MITSUBISHI
4/6/2005
LETTER TO ODI
ATTACHMENT
DOCUMENT NO. 26 - 34
PART 4 OF 4

Sender No: _____ Ref.No: _____ Subject: _____
M.I.D.1 - 0010 Request to Process Pre-Production EO for ST41/24/28 Head Light connector change

Sender No: LSS1-0078 Ref. No: Subject: Request of changes of Head lamp connector for ST41/24S/28

MMMA ST24/28/41 Melt Headlamp Connector

BH4759 (1/2)

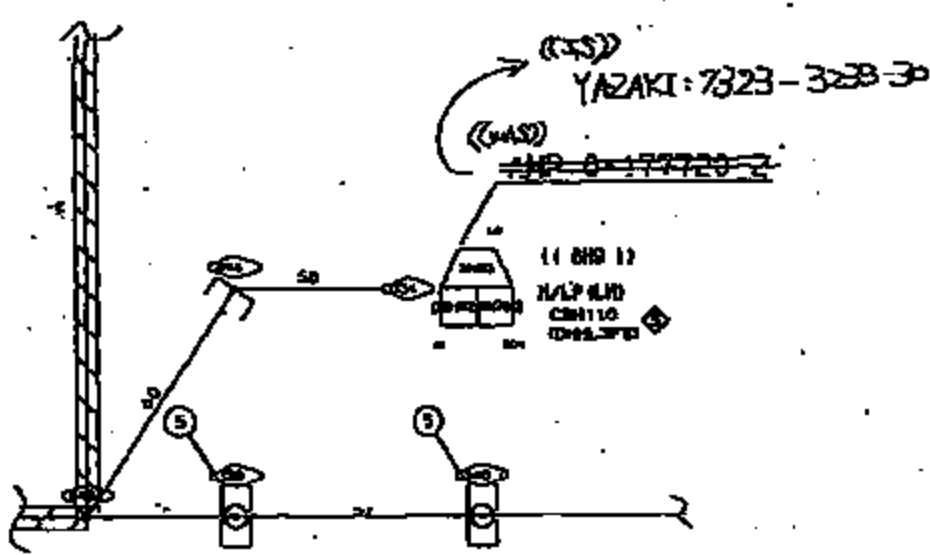
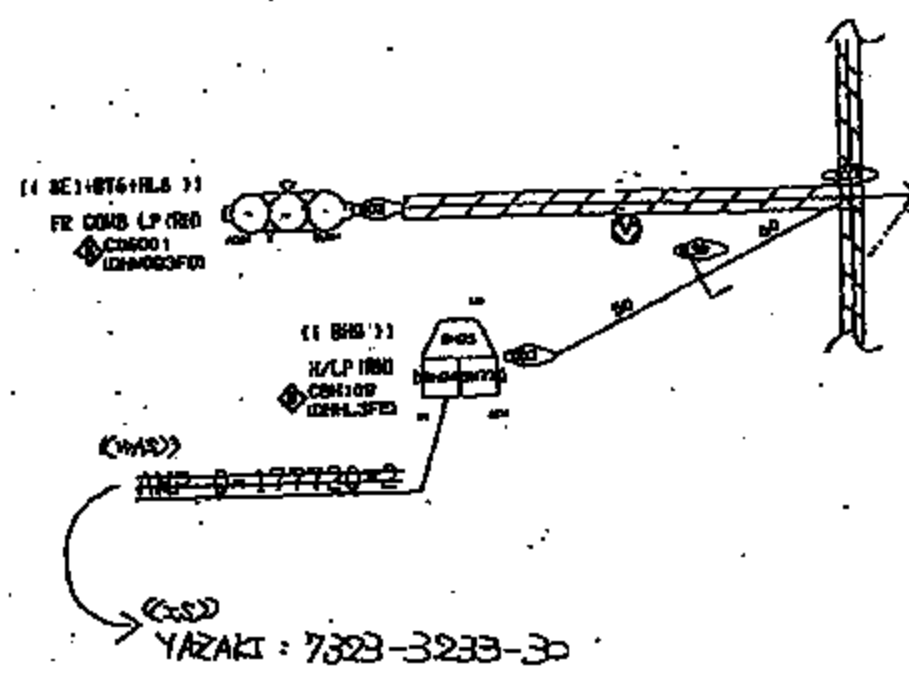
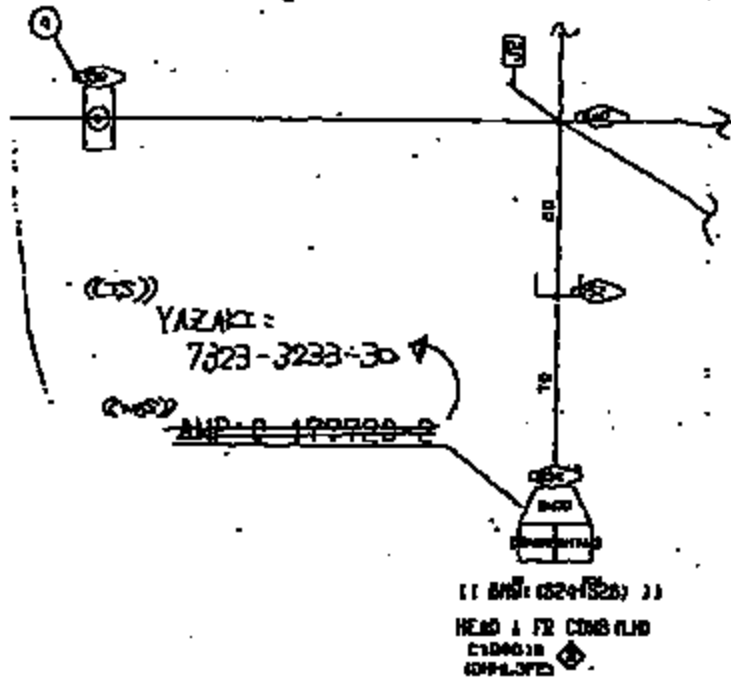
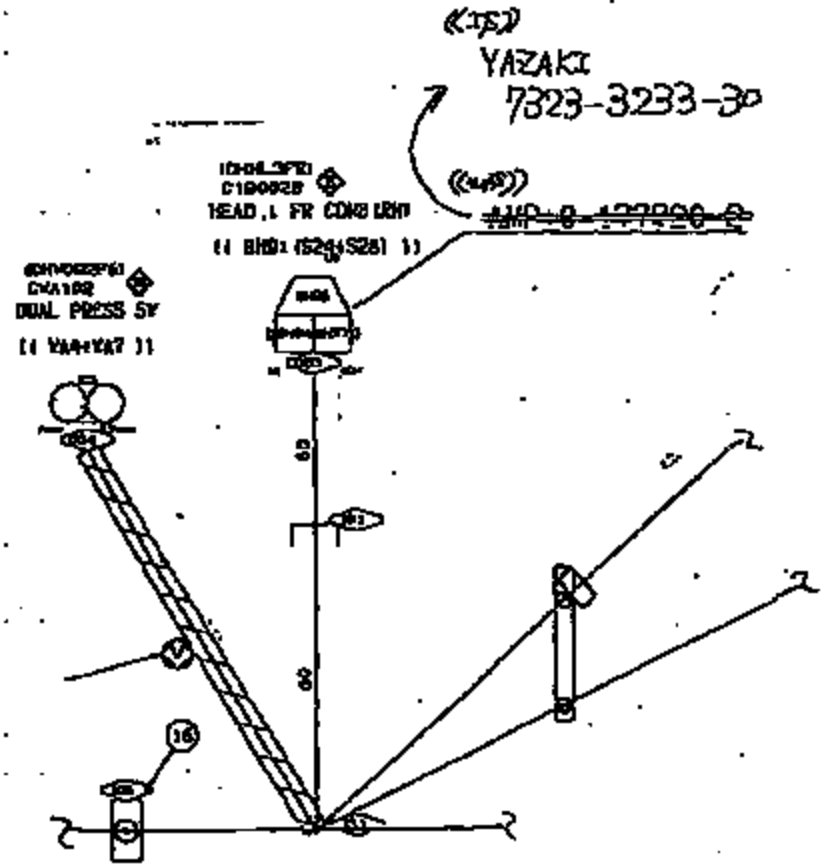
Abstract of trial:
 To change head light connector type from AMP to Yazaki made (LH & RH).

Part Name & No.	EO No.	REASON	CONTENTS
Pre-Production EO	BM4769	To avoid terminal twisting insertion	To change head light connector type (IS)Yazaki NQ type ↑ (WAS)AMP Q type

① CHANGE AS FOLLOWS

② CHANGE AS FOLLOWS

BP.18.12(1/2)

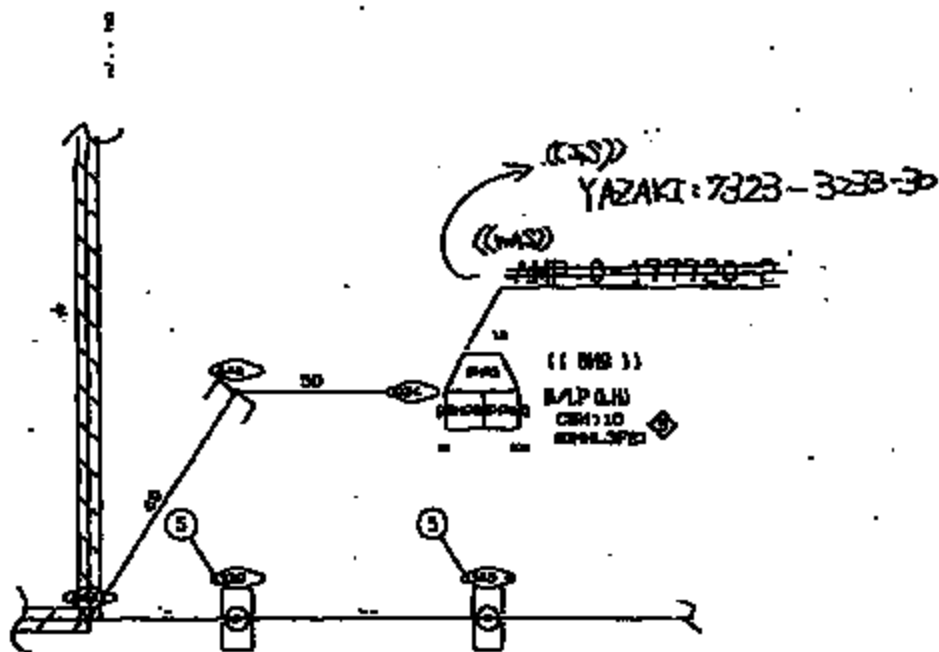
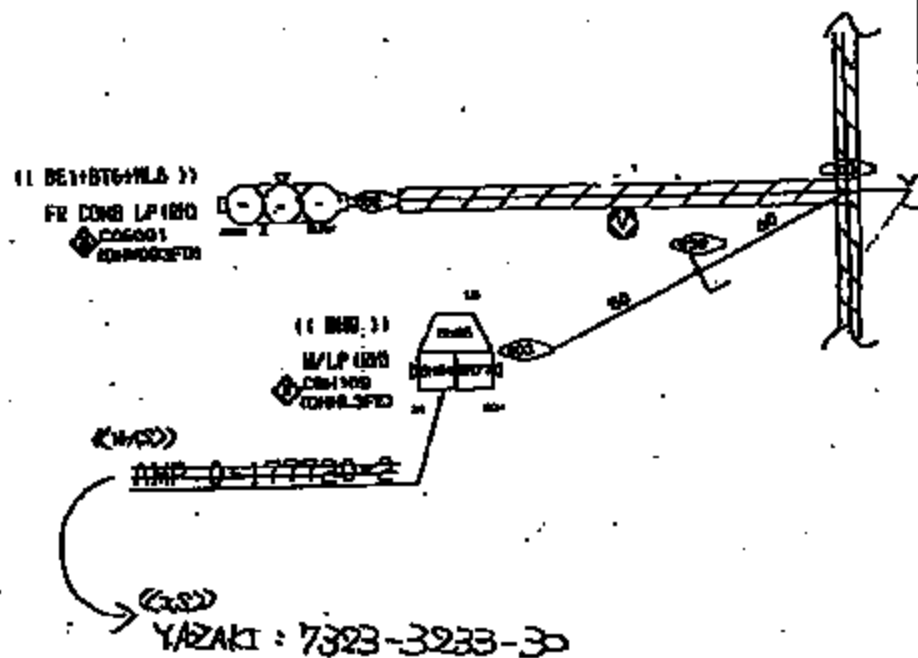
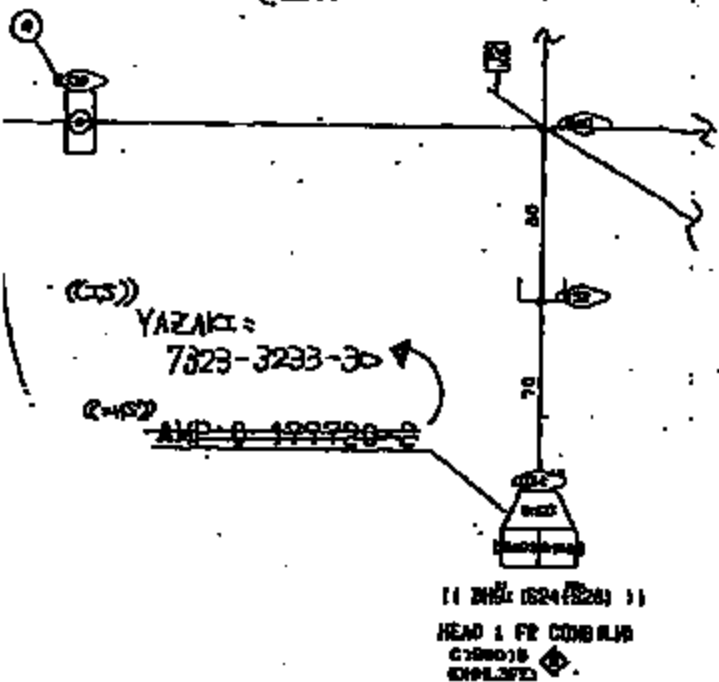
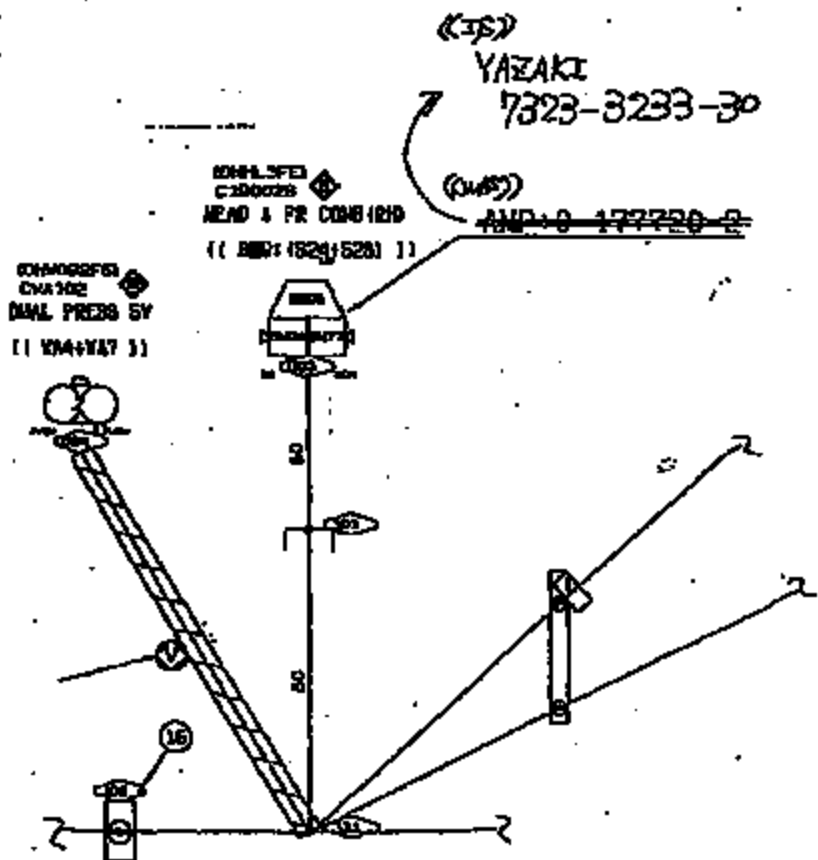
Part Number&Name	EO No.	Reason of change	Contents of change
MR583221: MR583231 MR588191 MR588281 (02Front harness)	BP1812	To avoid connector terminal from being twisted insertion	To change H/LP connector type
MR588286 MR588281 (03Front harness)	BP1816		To change H/LP connector type

SUBJECT	DWG-LIST NO.	PART NO.	P P S	PART NAME	DESCRIPTION	E * DESCRIPTION	E * DESCRIPTION	
							ORDERING PART NO.	ORDERING PART NAME
CD	MR583221 (1/)-(2/)	R MR583221-25	M C	WIRING HARNESS,FRONT		<1>'02 ST41 TO CHANGE H/LP CONN TYPE		
CD	MR583231 (1/)-(2/)	K MR583231-33	M C	WIRING HARNESS,FRONT		<2>'02 ST41 TO CHANGE H/LP CONN TYPE		
CD	MR588191 (1/)-(2/)	M MR588191	M C	WIRING HARNESS,FRONT		<3>'02 ST24S/28 TO CHANGE H/LP CONN TYPE		
"	"	" MR588193-97	" C	"				
CD	MR588261 (1/)-(2/)	F MR588261-63	M C	WIRING HARNESS,FRONT		<4>'02 ST24S/28 TO CHANGE H/LP CONN TYPE

CHANGE AS FOLLOWS

CHANGE AS FOLLOWS

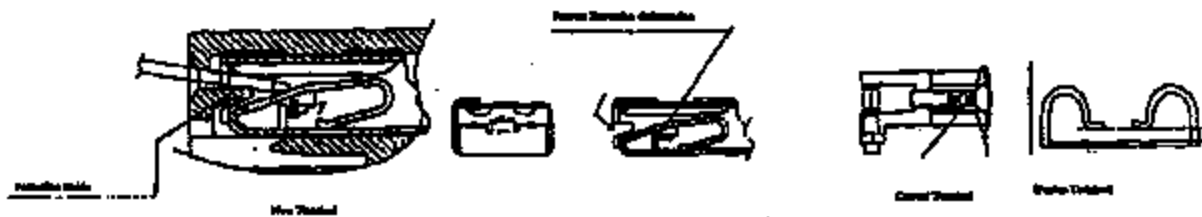
(1) Production Vehicle: EO BP1812 was issued on June 12th, 2001 to adopt new connector and terminal to ST41,24, and 28.

- Adoption of Anti-wiggling terminal:

Built-in protective guide at every cavity

Spring type contact for prevention of terminal deformation

- Terminal Material Change:

From brass (threshold: 120 D.C.) to a Copper alloy (threshold :140 D.C.)

Photo-1 test condition

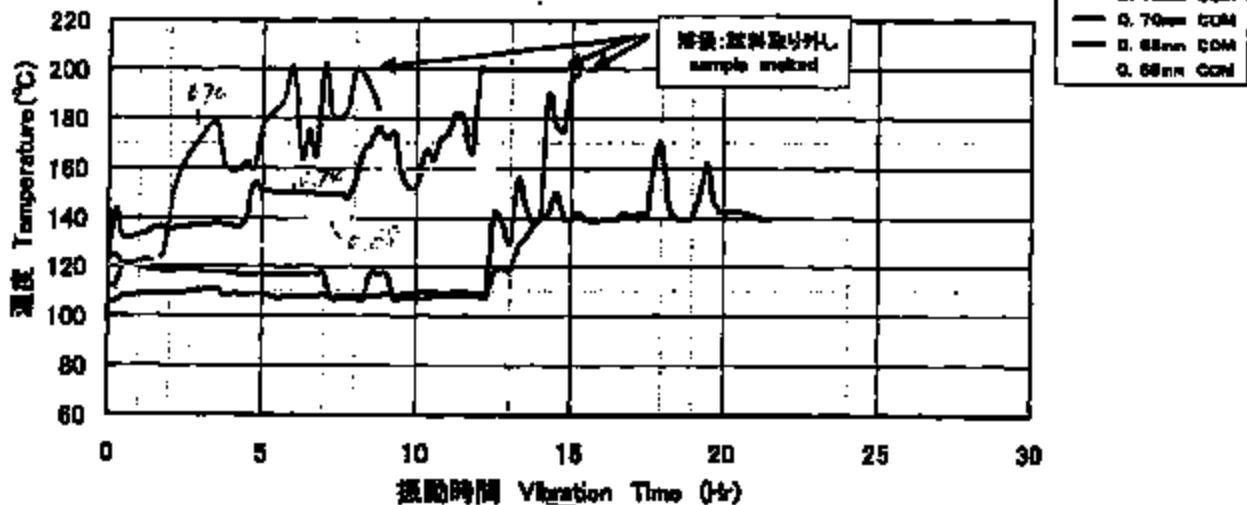
Terminal with more than 0.70mm contact gap had melted. Terminal with 0.68mm gap is still on going. Same test with NQ terminal will start.

Photo-1 test condition

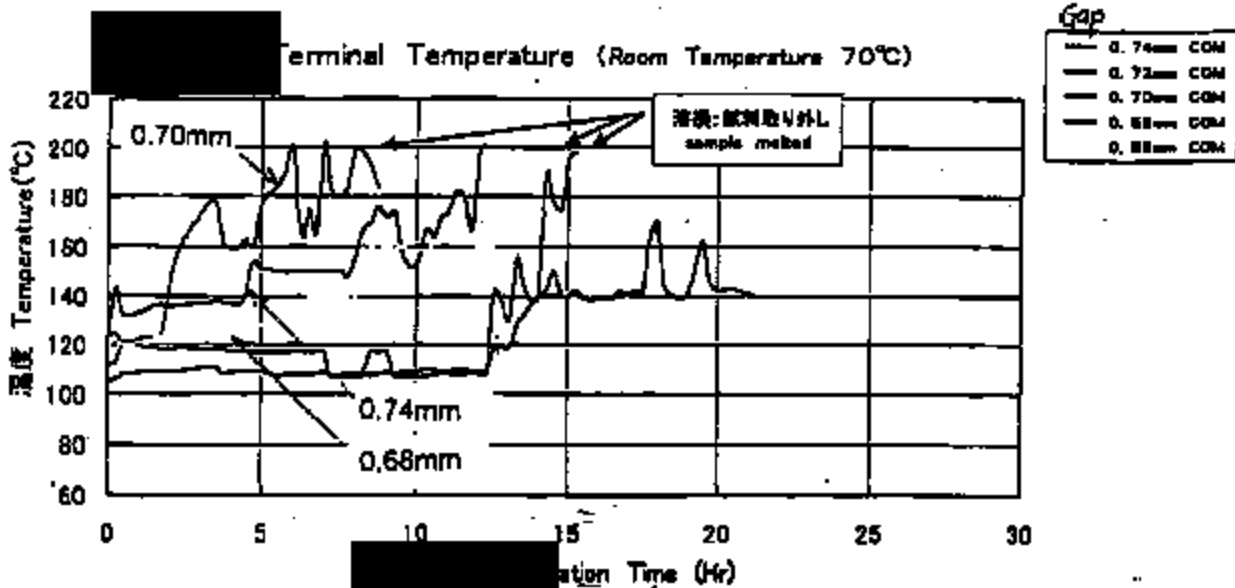
Terminal with more than 0.70mm contact gap had melted. Terminal with 0.68mm gap is still on going. Same test with NQ terminal will start.
